Nicollet County Board of Adjustment and Appeals

September 20, 2021
7:00 PM

7. **PUBLIC HEARING PLN21-32** ***Continued from August 16, 2021 Meeting***
   Applicant/Property Owner: Patrick and Shana Gieseke
   Request: After-the-fact variance to: expand a nonconforming structure; reduce the bluff setback; reduce the front yard setback; alter a bluff area for the after-the-fact construction of a dwelling addition; reduce the front yard setback for the purpose of constructing a replacement septic system; and allow fill to be placed in a protected bluff
   Location: Part of the Southeast ¼ of the Southeast ¼, and Part of Government Lot 2, in Section 35-111-31 in West Newtown Township
   Parcel Number: 13.035.1000

ATTACHMENT F.13
APPLICATION MATERIALS SUBMITTED

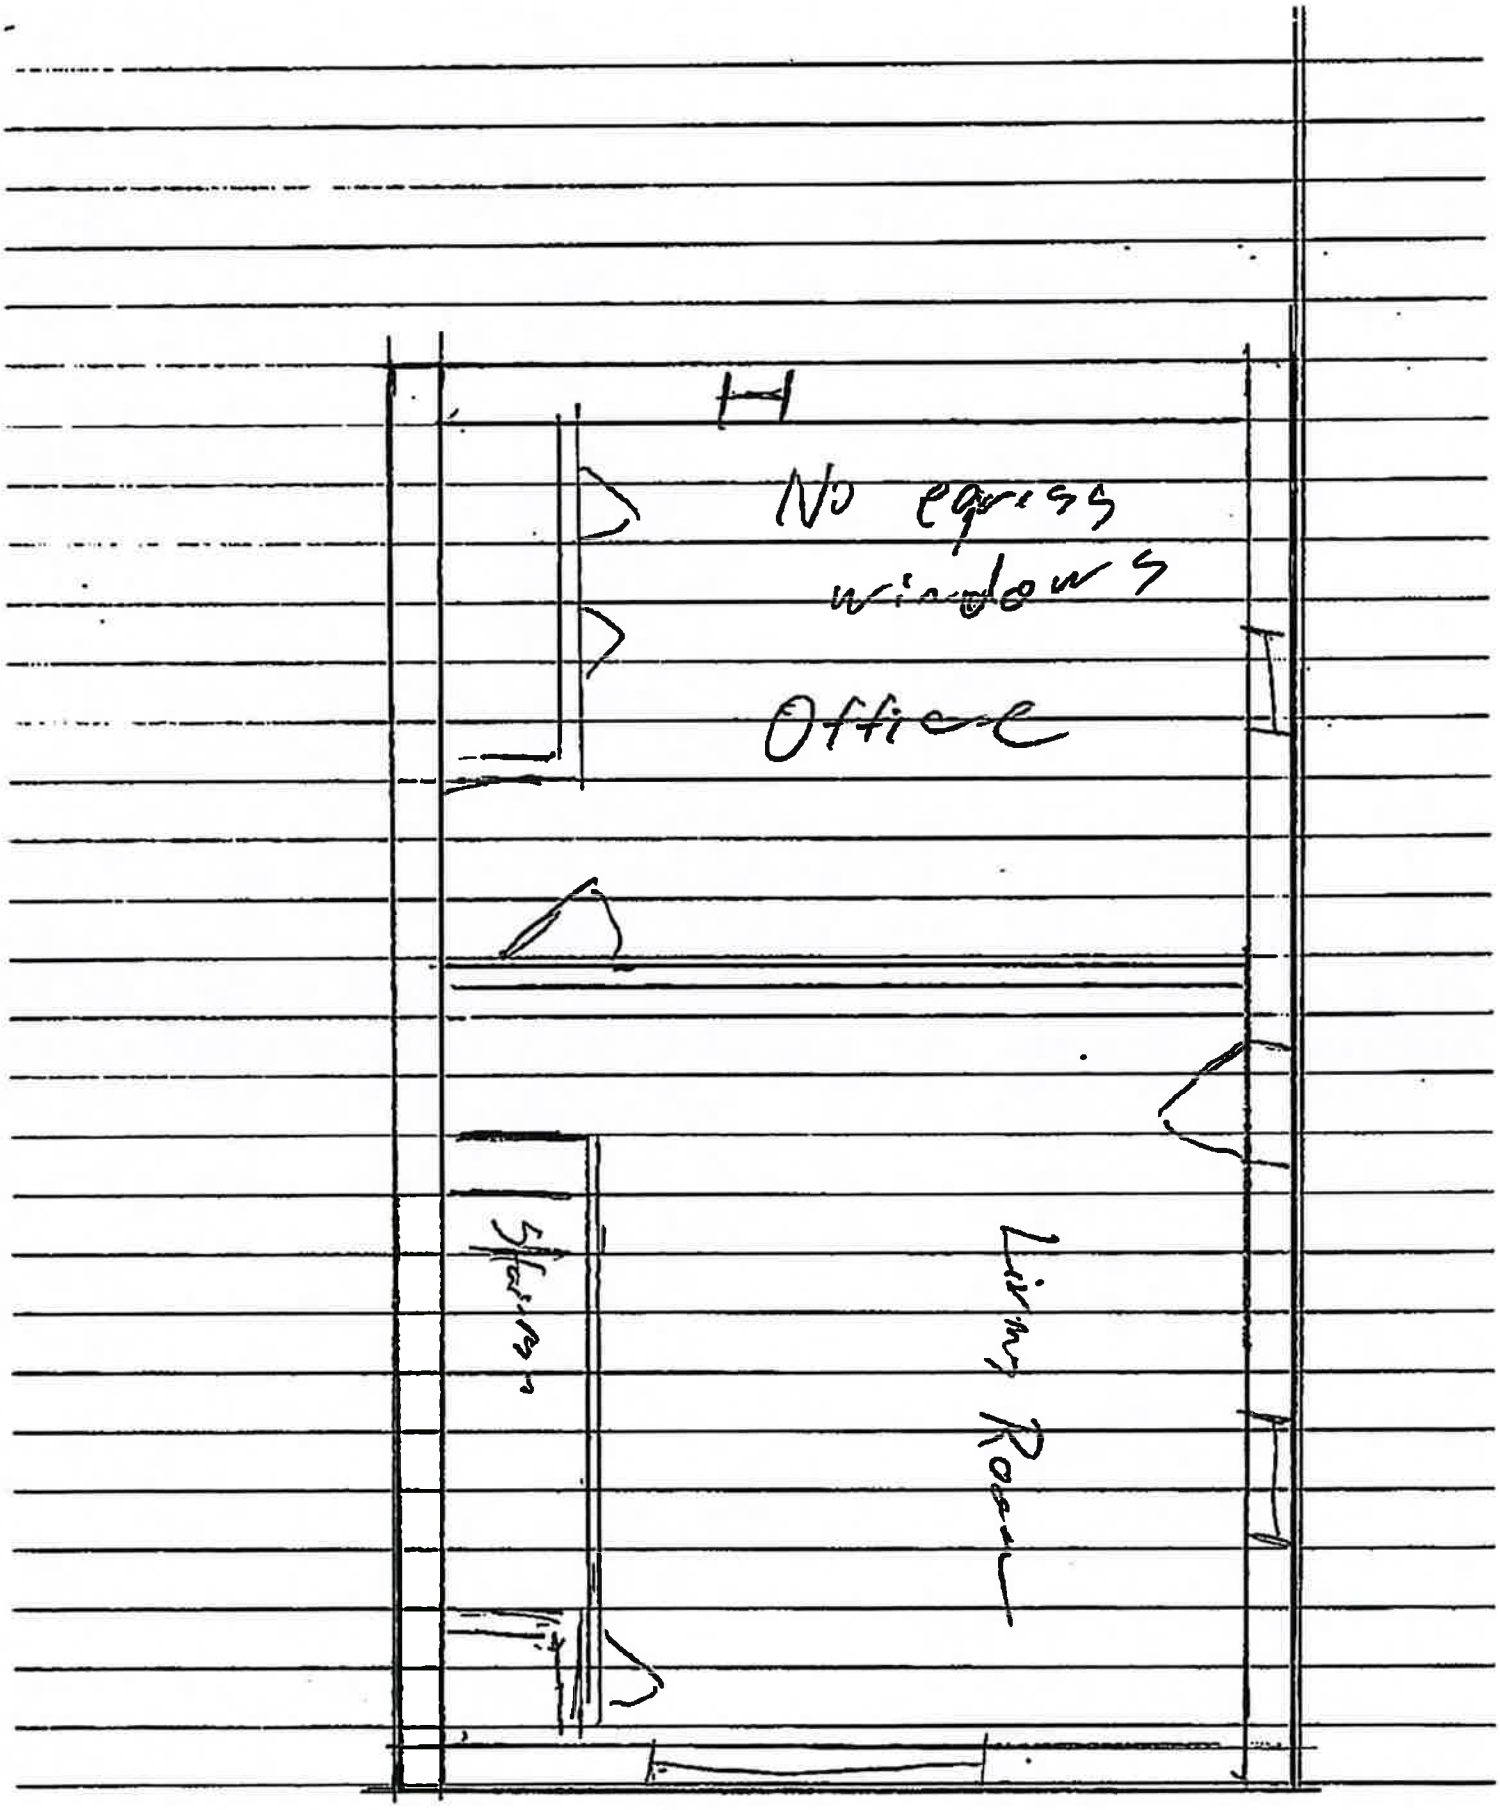
- A complete set of floor plans for the house and addition. The floor plan submitted was the addition only. The plans must include the entire house, including room use, egress windows, and closets.

Main Floor - Existing
12'
17' 6"
Main Floor
Living Room
No Egress Windows
Offset
20'
18'
12'
Stairs
32'

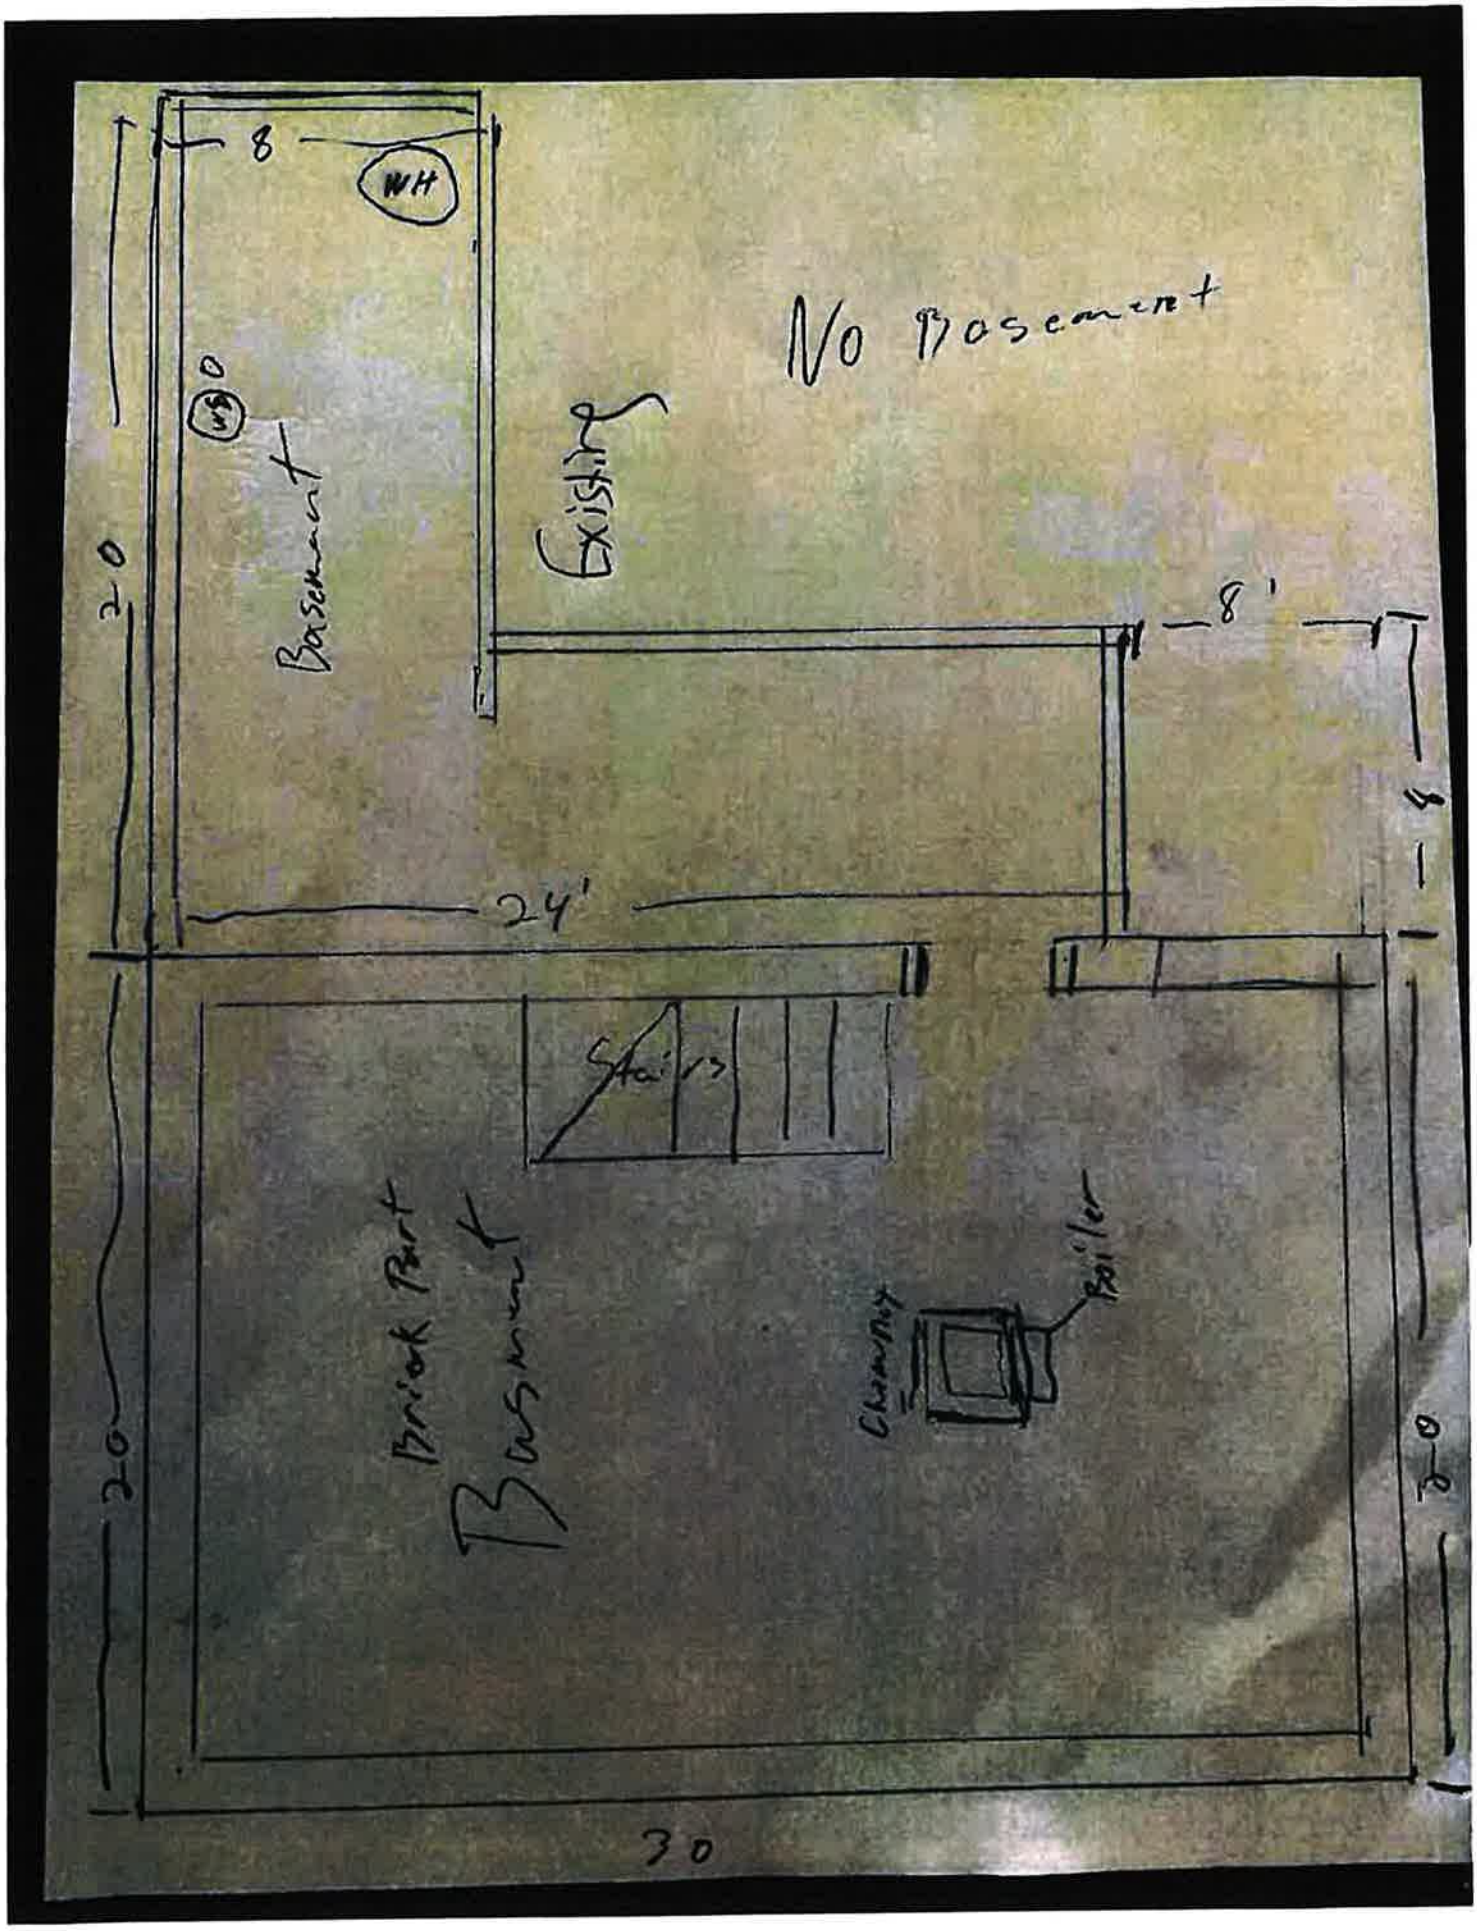
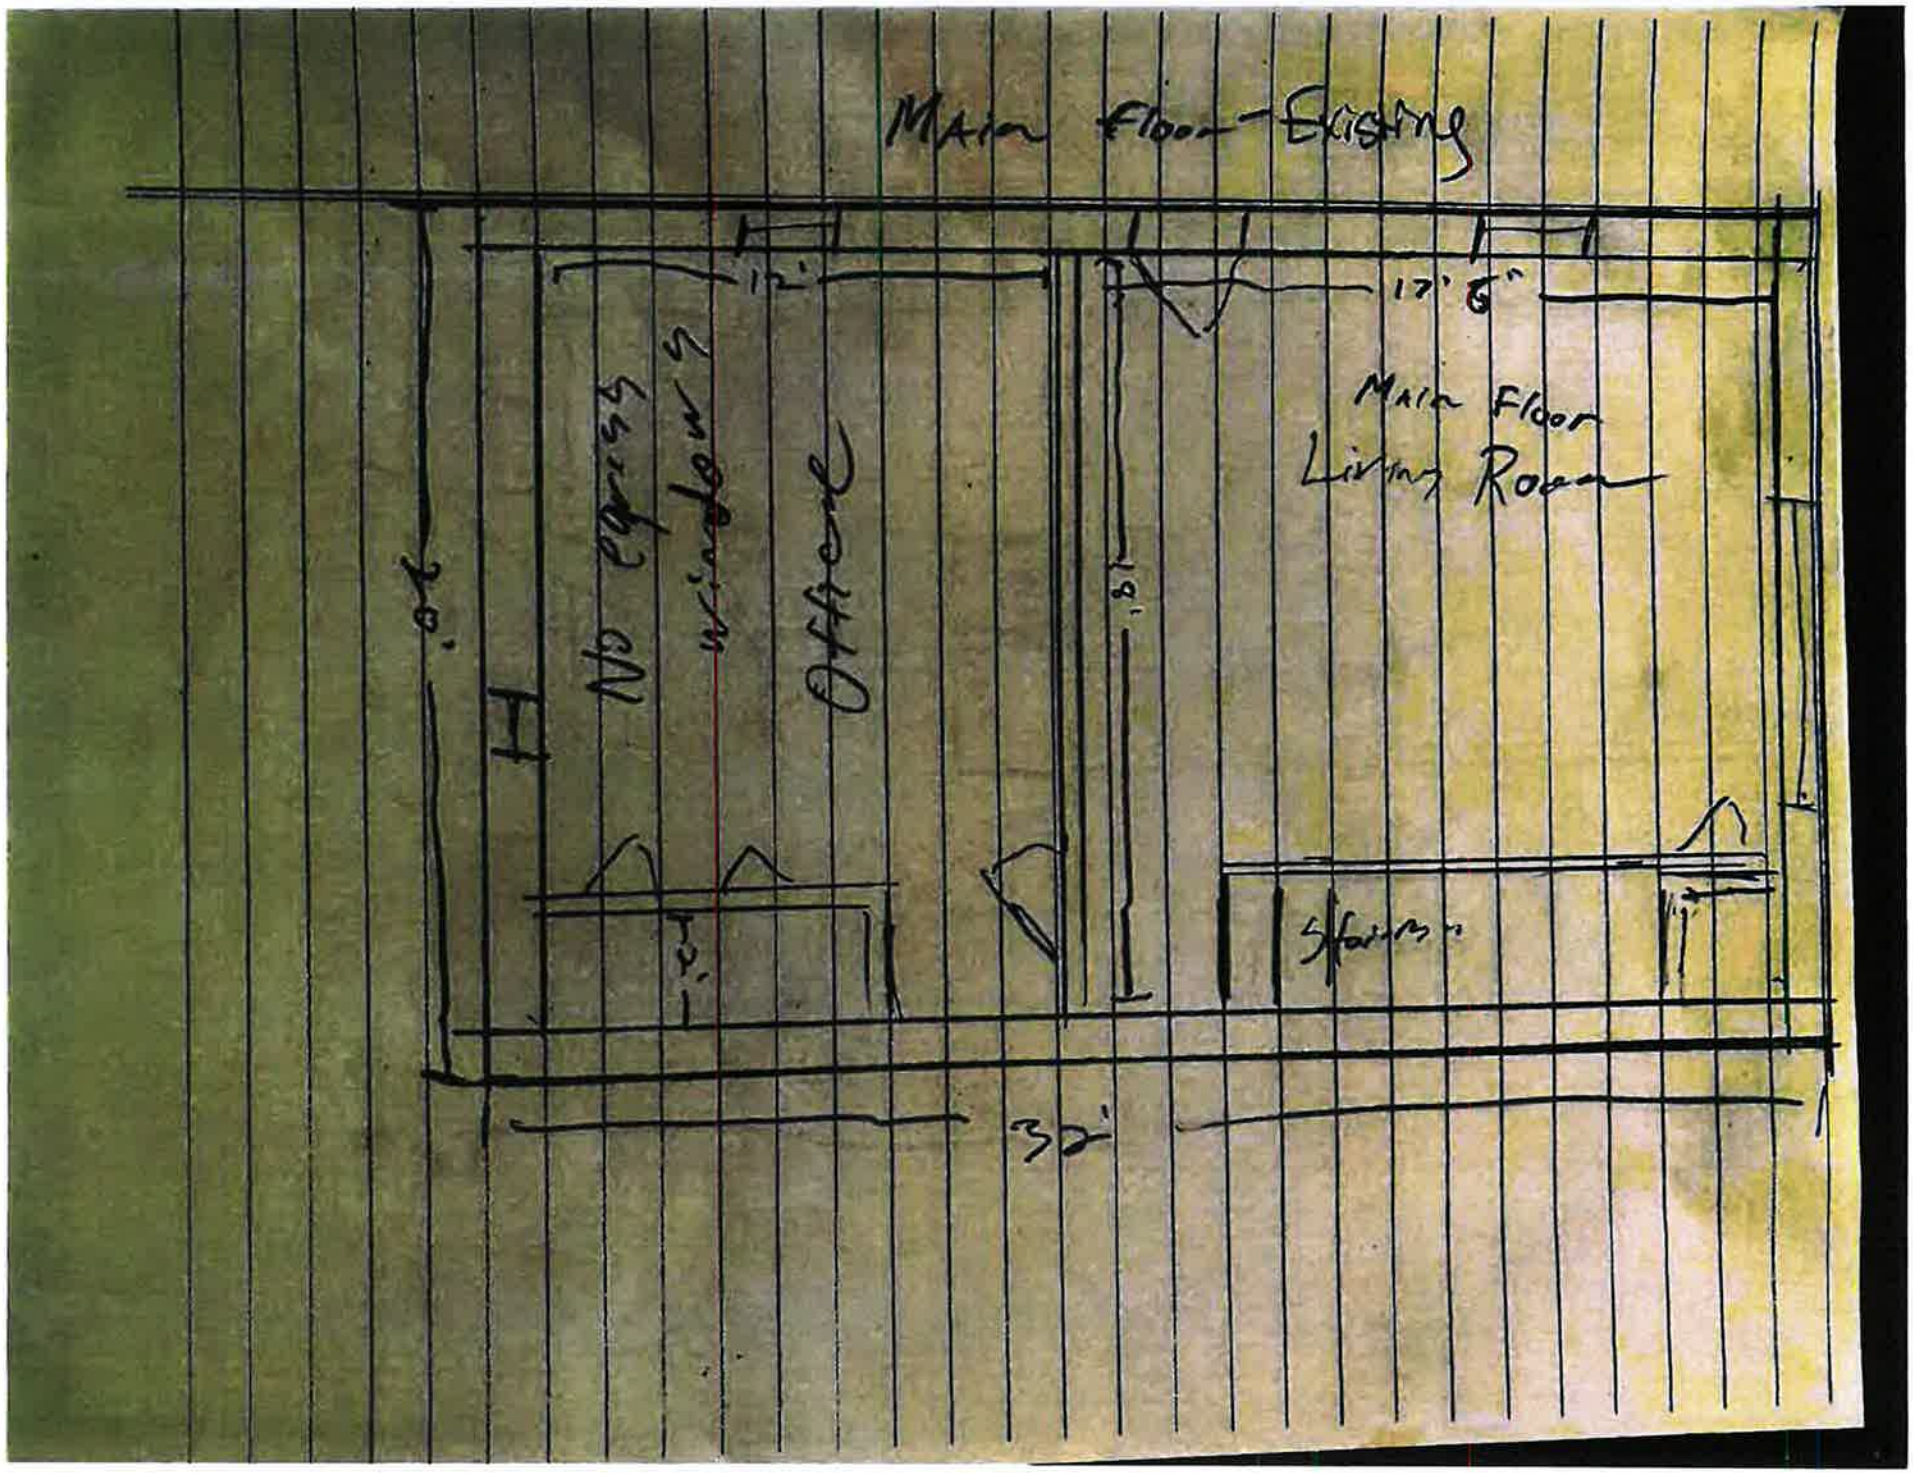
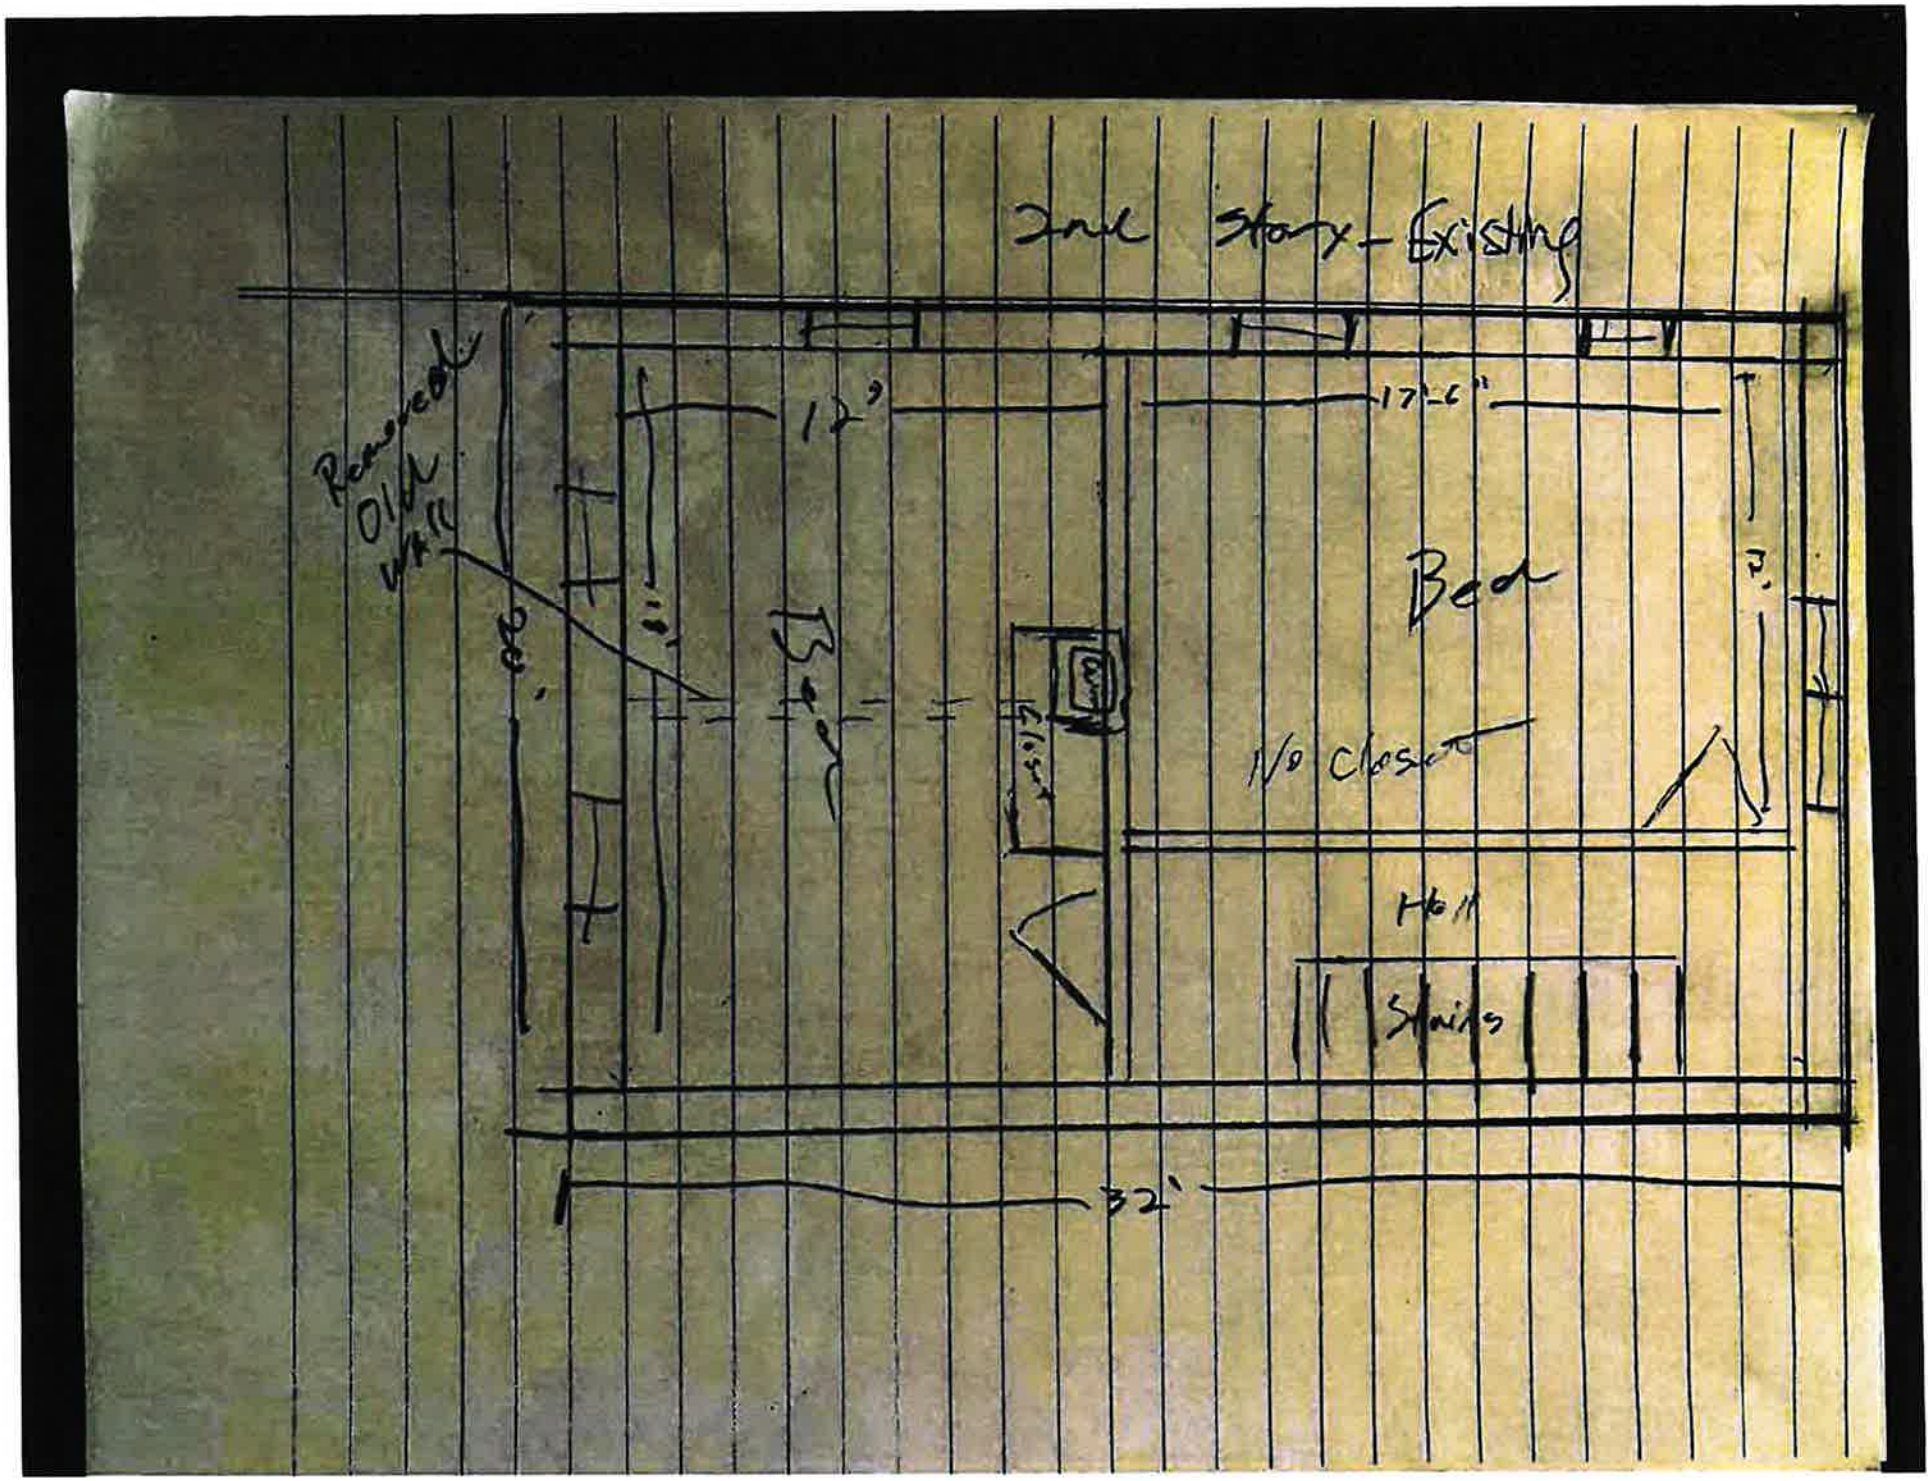
2nd Story - Existing
Removed Old Wall
12'
17'-6"
Bed
No Closet
Hall
Stairs
32'
